Access Compliance Report

Public Rights-of-Way

Intersection ID: 28401	Main Street: WADE_ARDREY_RD	Cross Street: MARVIN_RD	Location: NE
ADA ID: 65321D738B85	Ramp Type: Perpendicular	Initial Pass/Fail: Fail	Overall Compliance: No
		Severity Score: 30

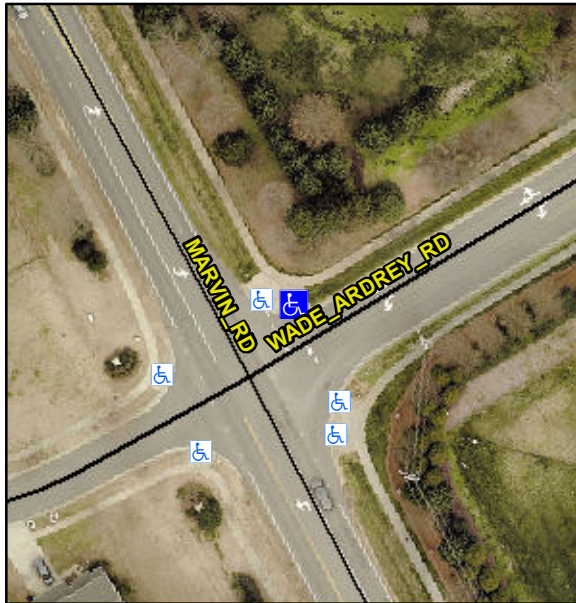
Not Found, R304.5.1, R304.5.3

Compliance	Description	Data	Compliance	Description	Data
N/A	Ramp Length (in)	60.0	Yes	Ramp Slope (%)	6.0
No	Ramp Width (in)	34.0	No	Ramp XSlope (%)	5.6
N/A	Flare Type LT	N/A	N/A	Flare Type RT	N/A
N/A	Flare Slope LT (%)	N/A	N/A	Flare Slope RT (%)	N/A
N/A	Flare Traversable LT?	N/A	N/A	Flare Traversable RT?	N/A
N/A	Landing Length (in)	N/A	N/A	DWS Provided?	N/A
N/A	Landing Width (in)	N/A	N/A	DWS Contrast?	N/A
N/A	Landing Slope (%)	N/A	N/A	DWS Length (in)	N/A
N/A	Landing X Slope (%)	N/A	N/A	DWS Full Width?	N/A
N/A	Landing Curb? (Y/N)	N/A	N/A	DWS Offset (in)	N/A
N/A	Shared Landing?	N/A			
N/A	Gutter Ponding?	N/A	N/A	Gutter Slope (%)	N/A
N/A	Gutter Lip Ht (in)	N/A	N/A	Gutter X Slope (%)	N/A
N/A	Painted X Walk1?	No	N/A	Painted X Walk2?	N/A
	X Walk 1 Direction	To SE		X Walk 2 Direction	N/A
N/A	X Walk 1 Width (in)	N/A	N/A	X Walk 2 Width (in)	N/A
	X Walk 1 Slope (%)	5.2		X Walk 2 Slope (%)	N/A
	X Walk 1 X Slope (%)	4.6		X Walk 2 X Slope (%)	N/A

Remove & Replace Entire Ramp.
